Given the large amount and extensive nature of PCD's comments on this drainage report, I will review the 2nd submittal of this doc like a 1st review.

PRELIMINARY DRAINAGE REPORT

GRANDVIEW RESERVE FILING NO. 1

El Paso County, Colorado

Figure 8-11. Inlet Capacity Chart Sump Conditions , Curb Opening (Type R) Inlet

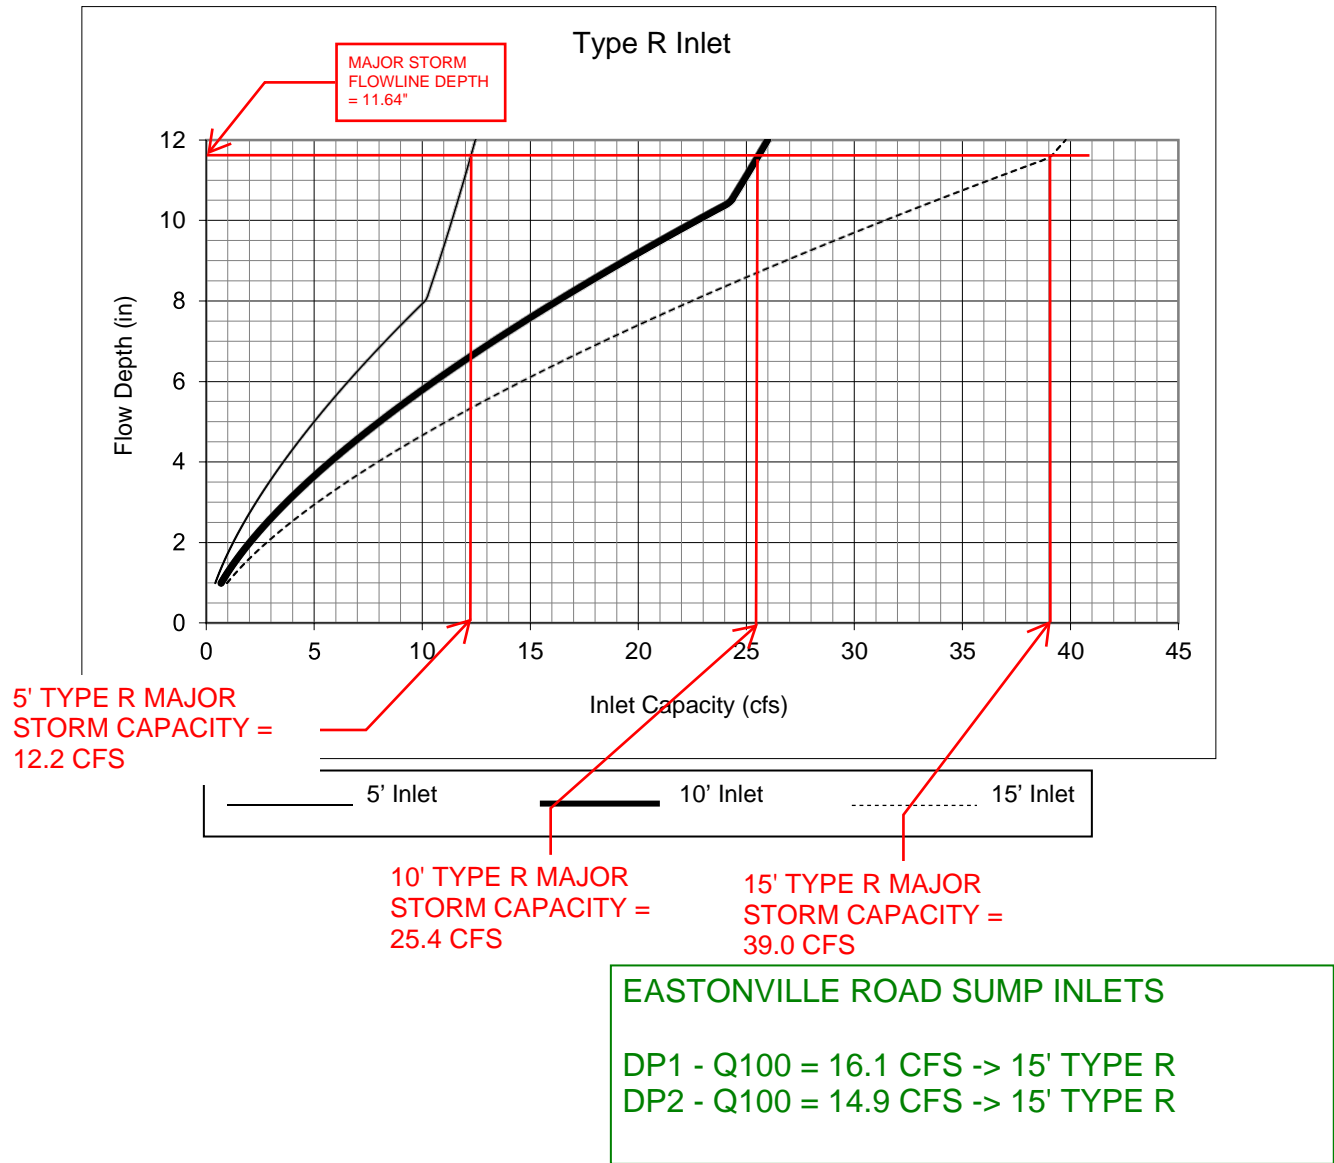
Remove inlet and pipe calculations not associated with the channel design and construction. These are approved on a different project application.

Provide the complete HEC-RAS Analysis with all input and output tables.
